LiDAR Quality Assessment Report

KS_Area3-NortheastA_2012

KS_25 COUNTIES LIDAR #1

FL_221_E

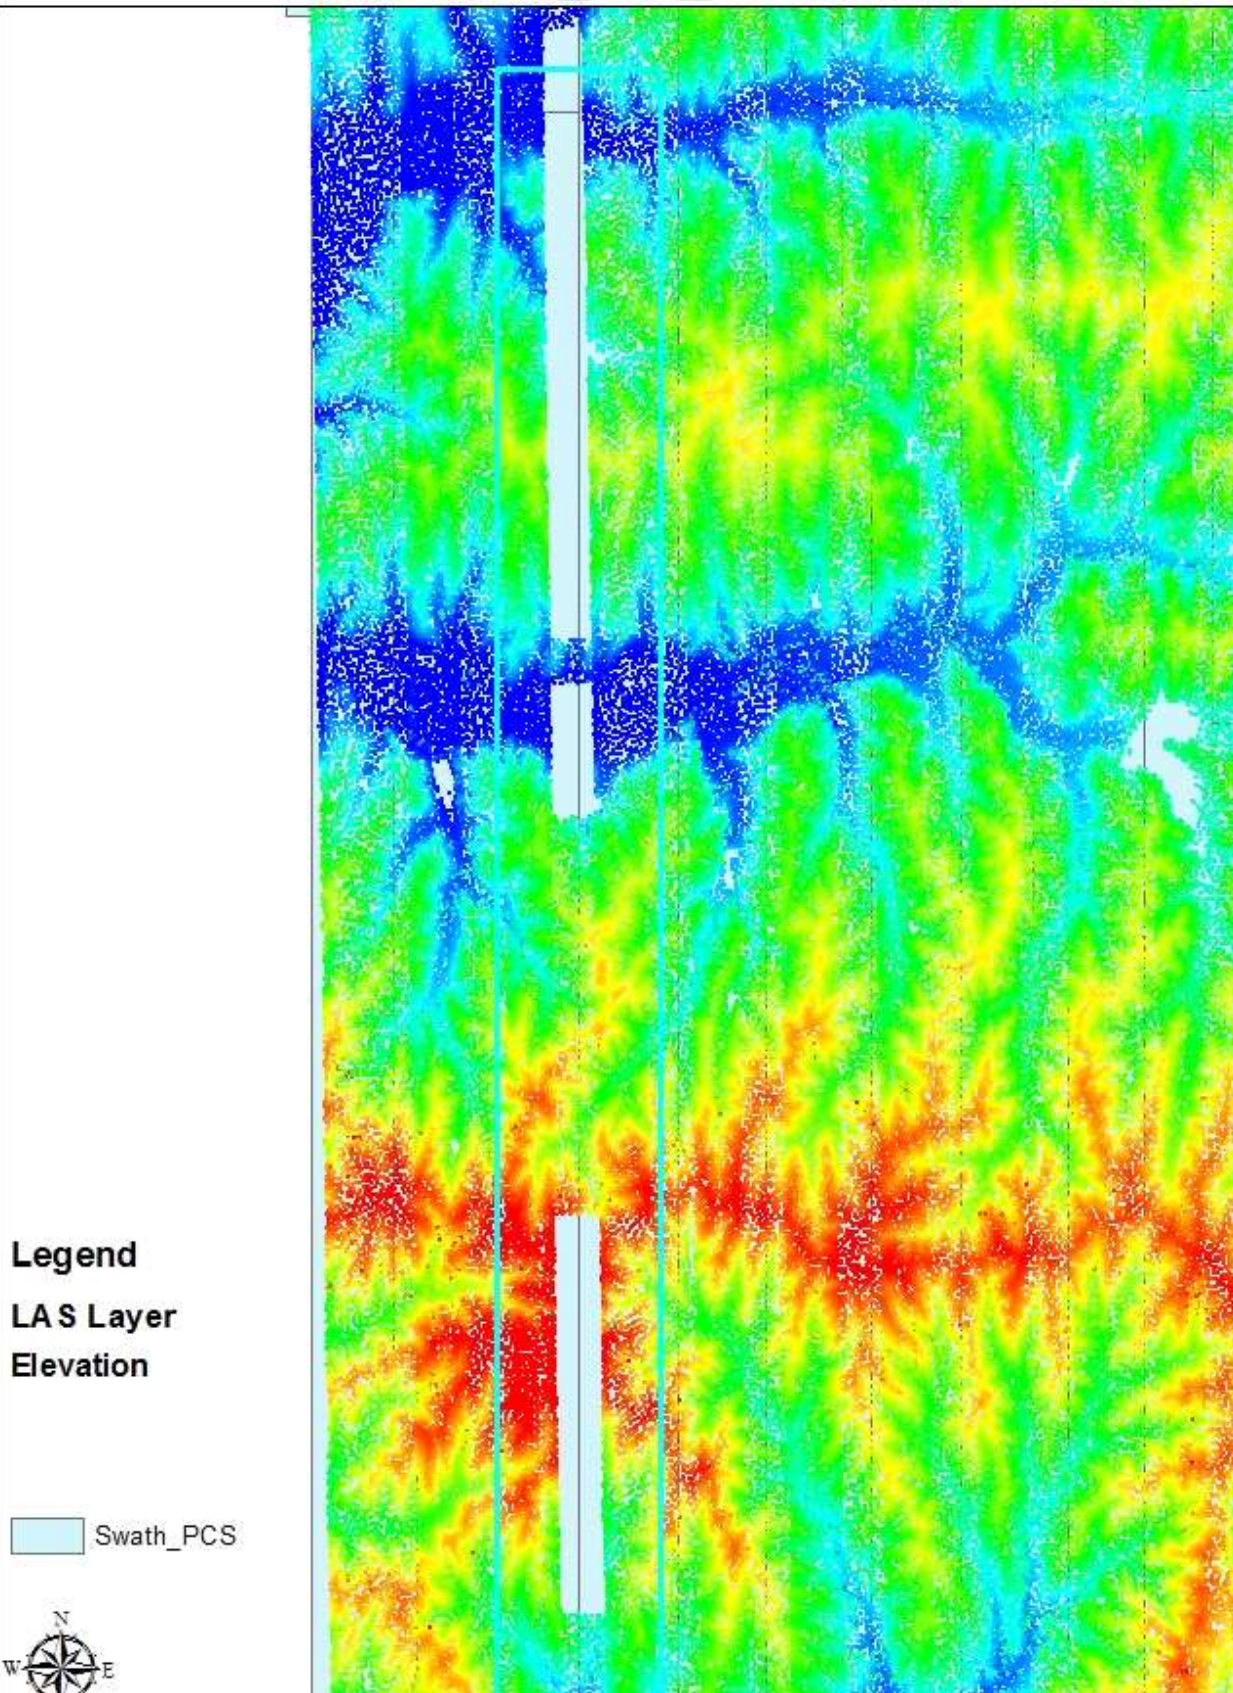
The scan angle shows -128 and 124 and there are missing points in the flight line. Number of classes used in this flight line is 6: Classes 0, 1, 4, 17, 18 and 26. There are classified .las points for this area. The above image shows missing data long FL 221E, FL 221F and FL 231B. Looking at the classified .las and DEM, there are points in the missing areas noted in the swath.

**There were no re-deliveries of swath data by the vendor.

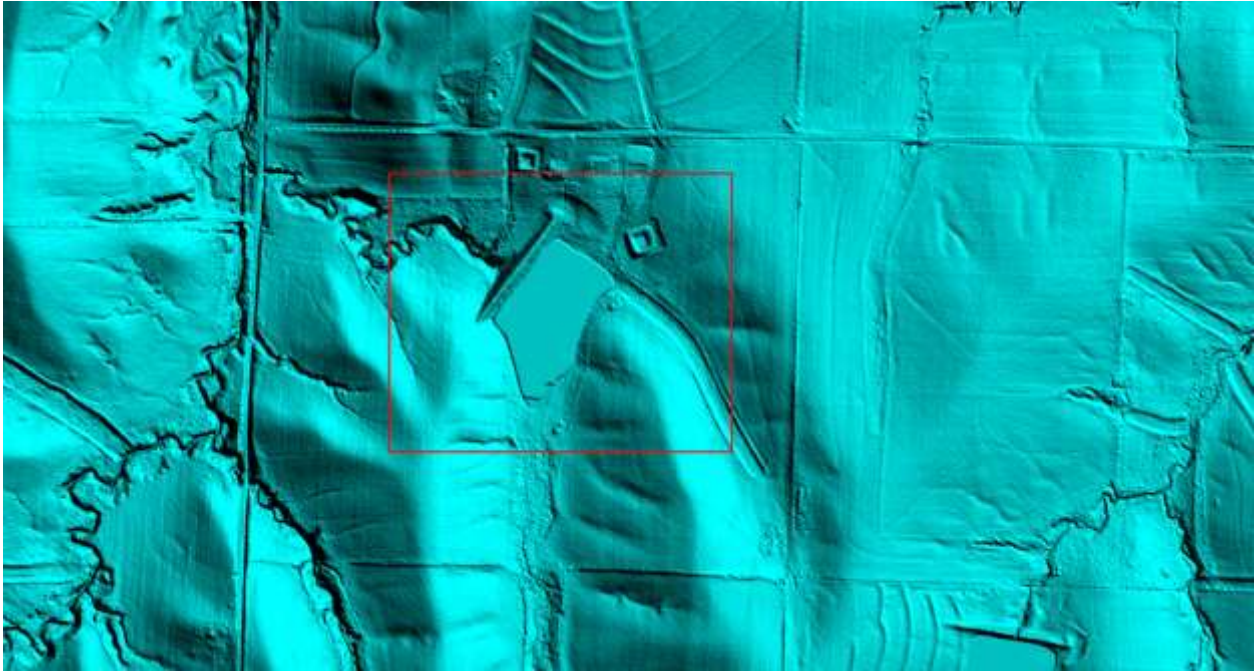
Water that is higher than the terrain. Location at 39° 25' 8.7115" N, 95° 47' 19.6699" W

****Vendor corrected error****

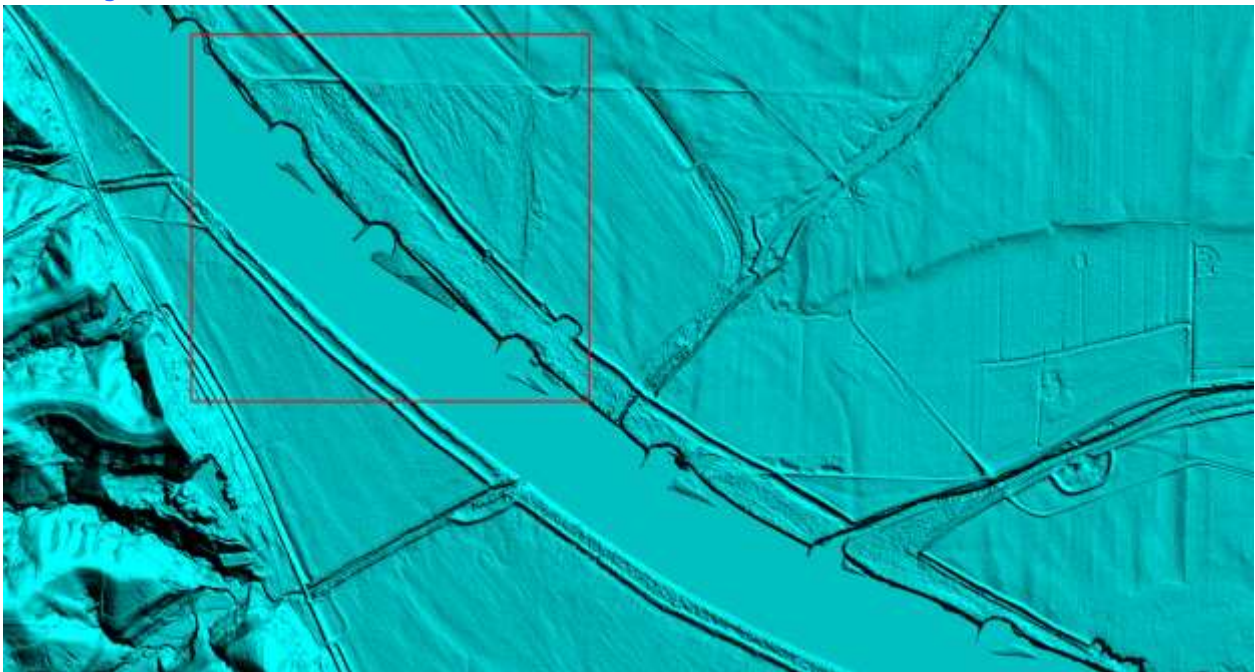
Along a portion of the creek, there are errors relating to tinning across the water, land below water and areas that look as if too many points were removed along the bank.

Not Corrected by vendor

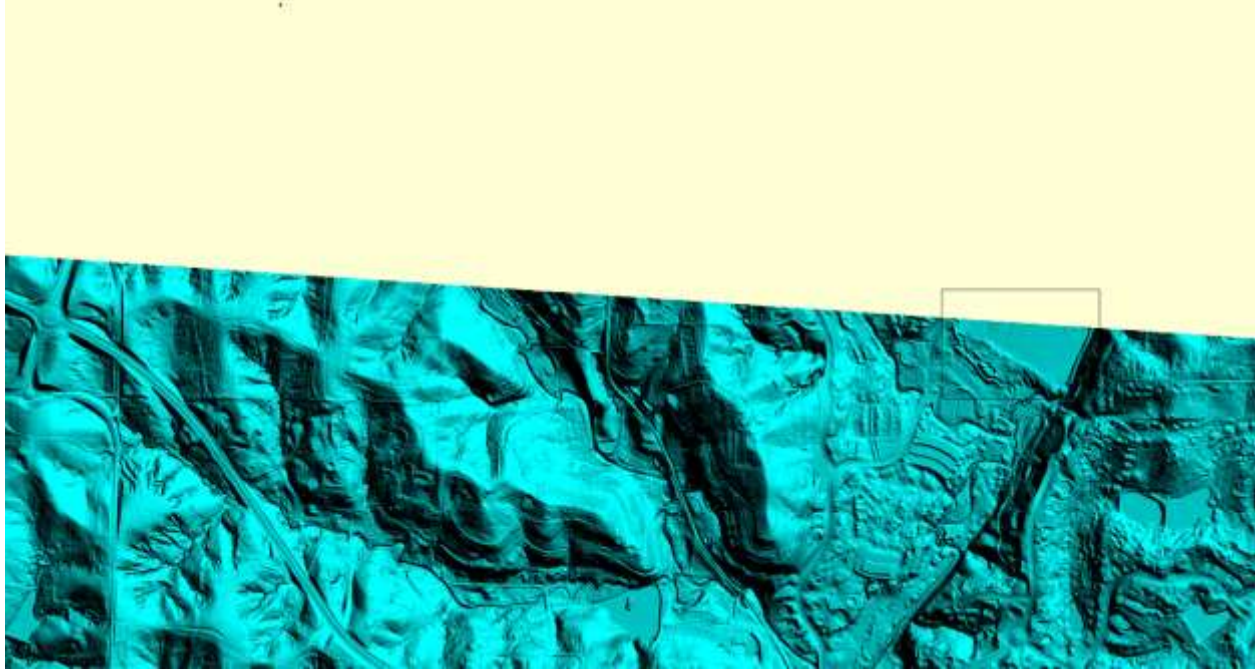
Water body on edge of data that was not completely hydroflattened.

Vendor corrected error
